STAFF RECOMMENDATION
1430-B Greenwood Avenue
September 20, 2017

Application: New construction – infill and outbuilding
District: Eastwood Neighborhood Conservation Zoning Overlay
Council District: 06
Map and Parcel Number: 08302037100
Applicant: Sathan LLC
Project Lead: Paul Hoffman, paul.hoffman@nashville.gov

<p>Description of Project: Application for new residence with detached outbuilding.</p> <p>Recommendation Summary: Staff recommends approval with the conditions:</p> <ol style="list-style-type: none">1. Lap siding shall have a five inch (5”) reveal;2. The finished floor height shall be consistent with the finished floor heights of the adjacent historic houses, to be verified by MHZC staff in the field;3. Staff approve the final details, dimensions and materials of windows and doors prior to purchase and installation;4. The HVAC shall be located behind the house or on either side, beyond the mid-point of the house; and5. Staff approve the roof color and masonry color, dimensions and texture. <p>Staff finds that the proposed application meets Section II.B for New Construction of the Eastwood Neighborhood Conservation Zoning Overlay design guidelines.</p>	<p>Attachments A: Pho

SITE PLAN
A0.01H

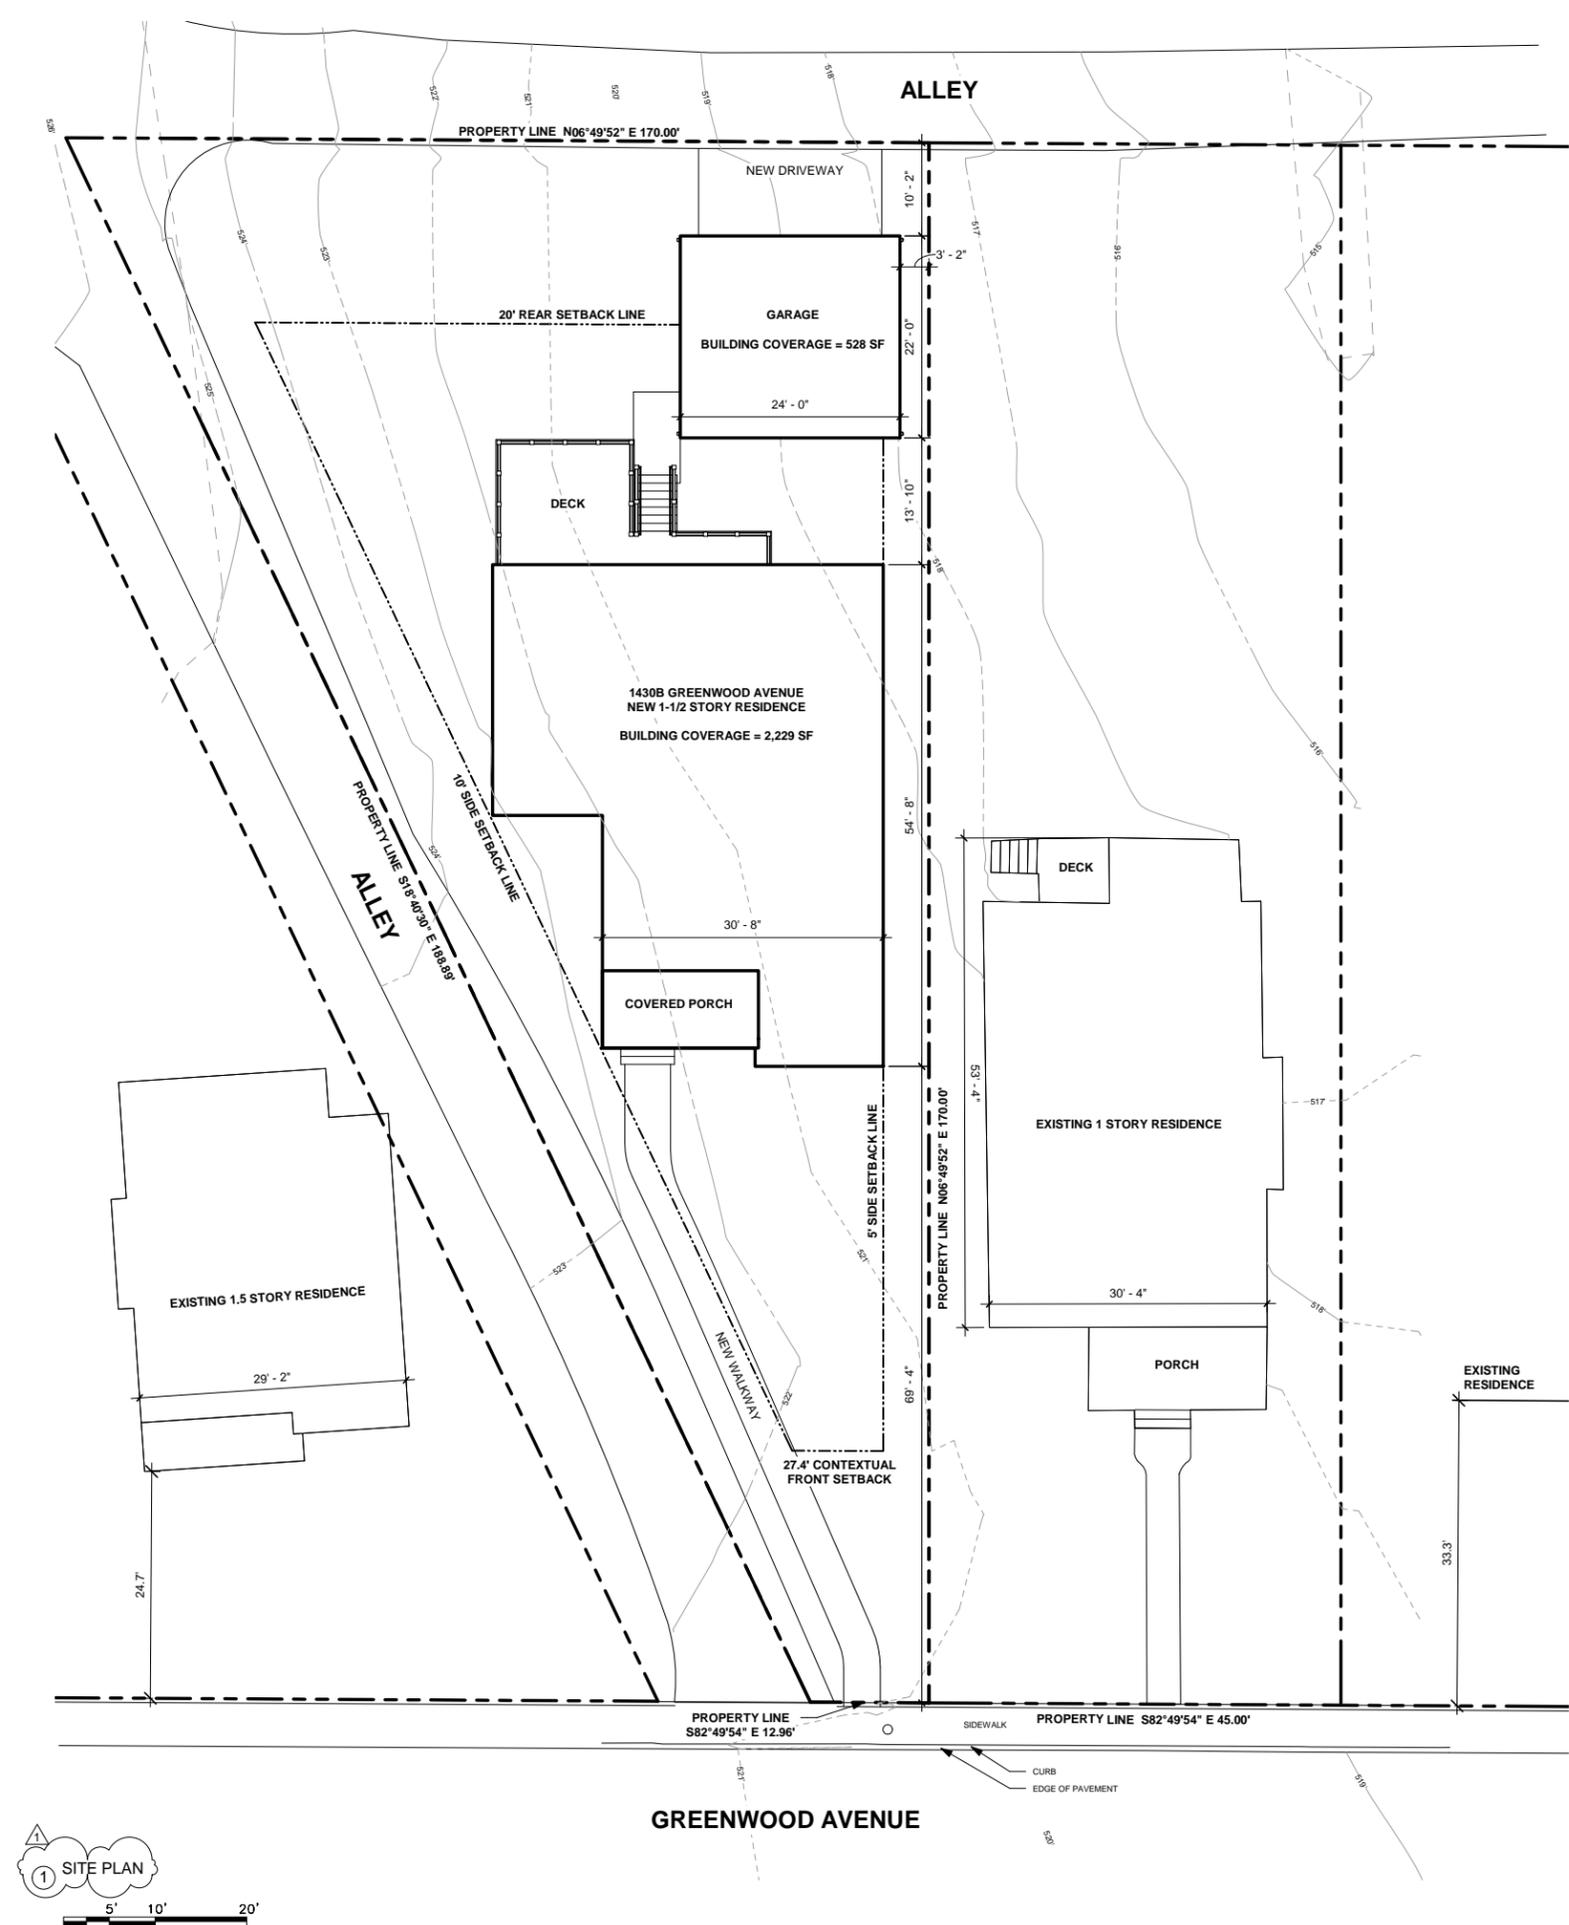
Setback & Rhythm of Spacing: The new structure has a front setback of sixty-nine feet, four inches (69' 4"). The front setbacks of the adjacent buildings are twenty-eight feet (28') and forty feet (40'). As this lot is so thin at the front, it would be impracticable to maintain the same setback as the neighboring homes. Although the proposed front setback is deeper than the average setback in the immediate context, Staff finds it to be appropriate given the conditions of the lot. The building meets side setbacks of five feet (5') on the right and ten feet (10') on the alley side on the left. The rear of the building will be forty-four feet (44') from the rear property line, more than the required twenty feet (20'). The project meets section II.B.1.c.

Site Planning & Setbacks: It will be at the rear of the lot, with a rear setback of ten feet, two inches (10' 2") and side setbacks of three feet, two inches (3' 2") and fifty feet (50') from the right and left sides, respectively. It will be separated from the house by thirteen feet, ten inches (13' 10"). Normally the Commission has required a separation of at least twenty feet (20') between the buildings; in this case, Staff finds the lesser separation appropriate due to the unusual lot size and shape.

Staff finds that the proposed location meets Section II.B.h.2.

A2.00H

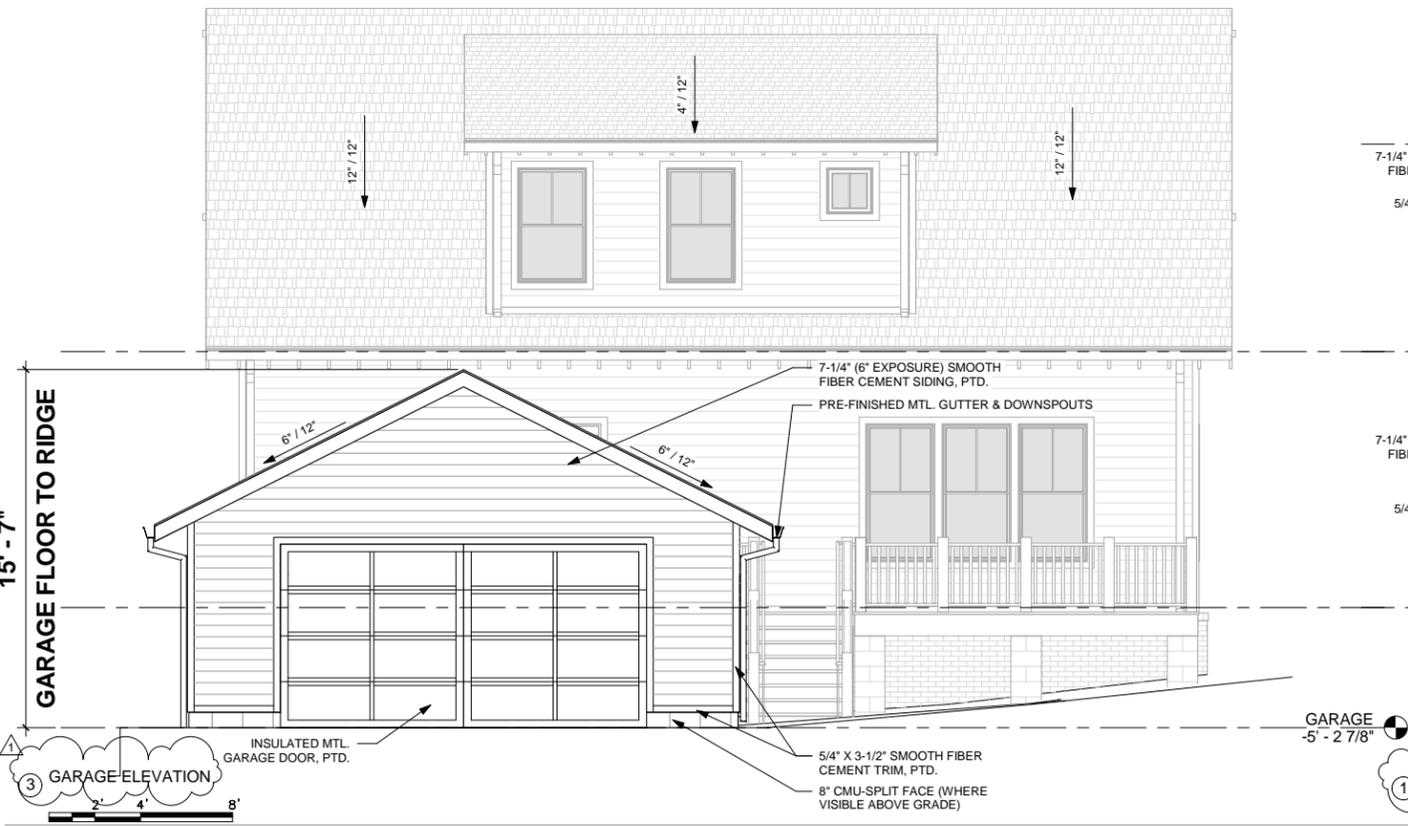
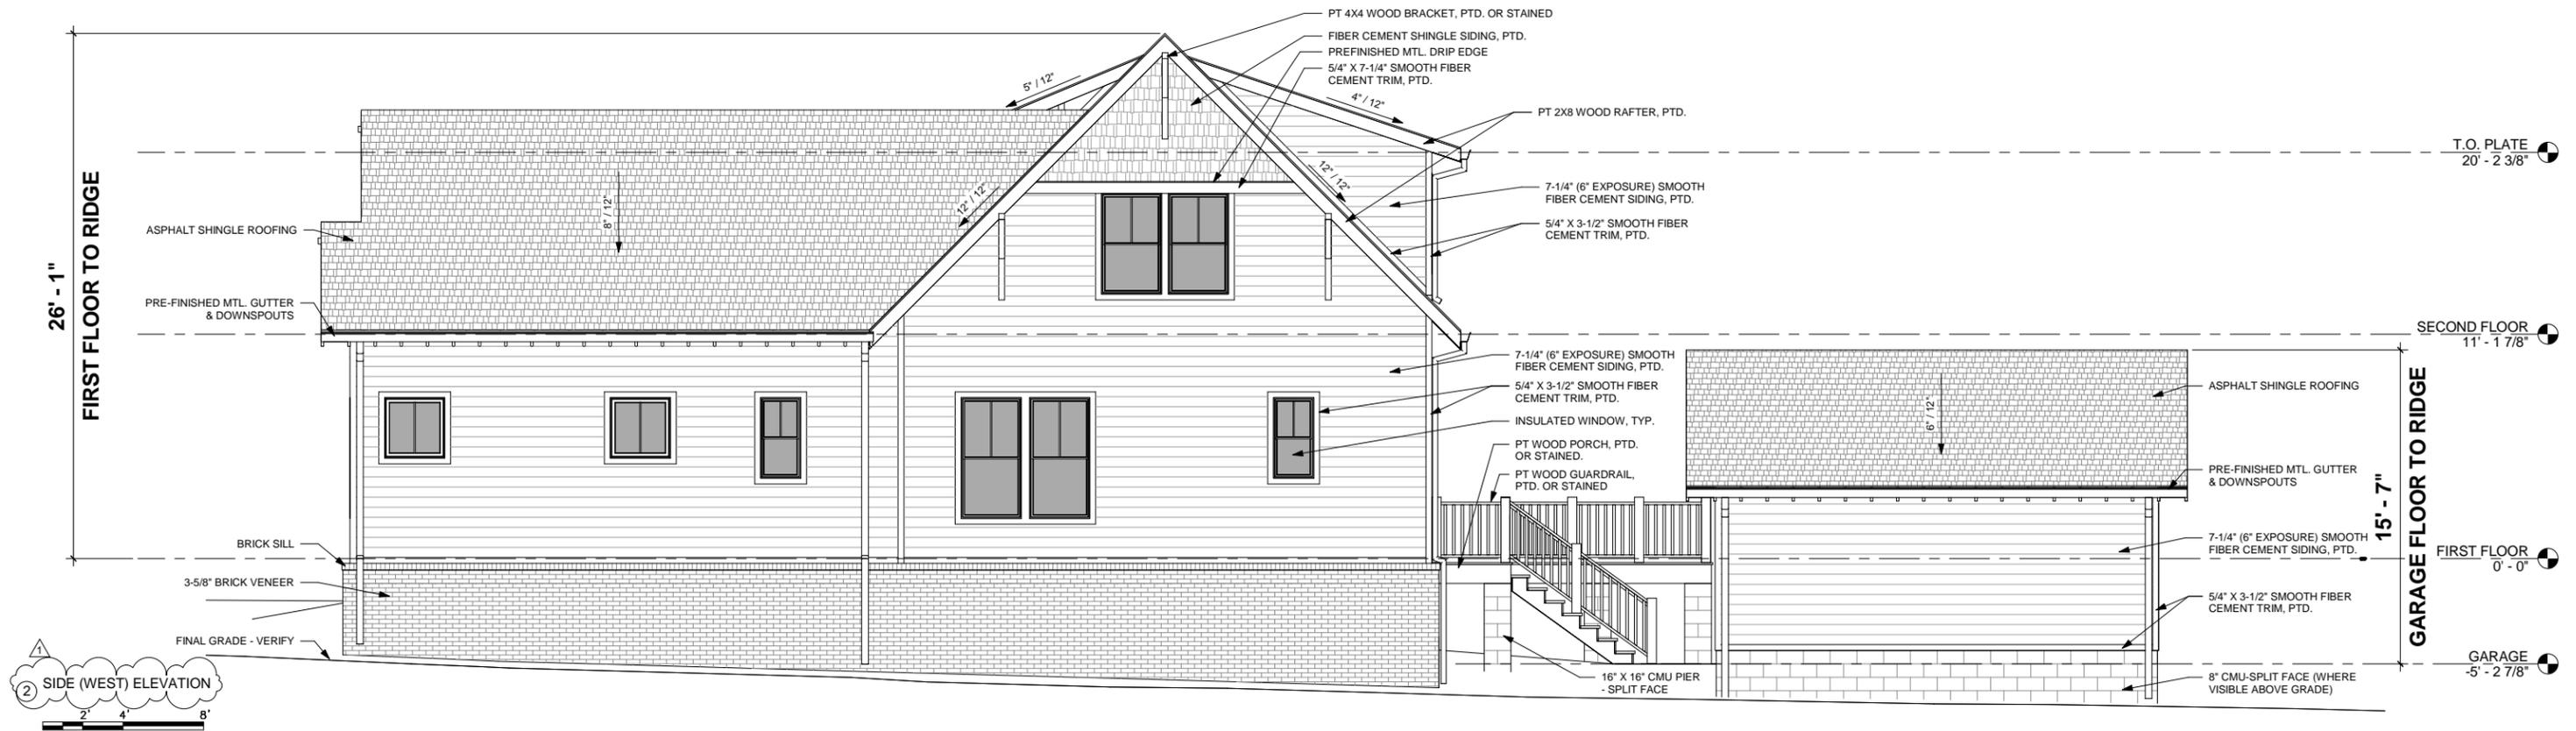
The new building is proposed with smooth-faced fiber-cement siding with six inches (6”) reveal. The guidelines allow for a reveal greater than five inches (5”) and up to eight inches (8”) when corners are mitered. However, as the proposed building has corner boards, it is Staff’s recommendation that the siding have no more than a five inch (5”) reveal. The foundation will be brick; Staff asks for approval of the masonry prior to purchase and construction. Details of windows and doors were also not specified; Staff asks to approve the final window and door selections prior to purchase and installation. With the staff’s final approval of the roofing color, masonry, windows and doors, the application meets section II.B.1.d for materials.

Roof form: The proposed building roof is a side-gabled form. The front section has a front-facing gable. The roof pitches are 8/12 or 12/12. Shed dormers on the front and rear roofs are 6/12 and 4/12 respectively. Staff finds that the roof form of the project is compatible with the context, and meets section II.B.1.e.

Proportion and Rhythm of Openings: The windows are approximately twice as tall as they are wide, meeting the historic proportion of openings. There are no large expanses of wall space without a window or door opening. Staff finds the project’s proportion and rhythm of openings meets Section II.B.1.g.

1. Lap siding shall have a five inch (5”) reveal;
2. The finished floor height shall be consistent with the finished floor heights of the adjacent historic houses, to be verified by MHZC staff in the field;
3. Staff approve the final details, dimensions and materials of windows and doors prior to purchase and installation; and,
4. The HVAC shall be located behind the house or on either side, beyond the mid-point of the house; and
5. Staff approve the roof color and masonry color, dimensions and texture.
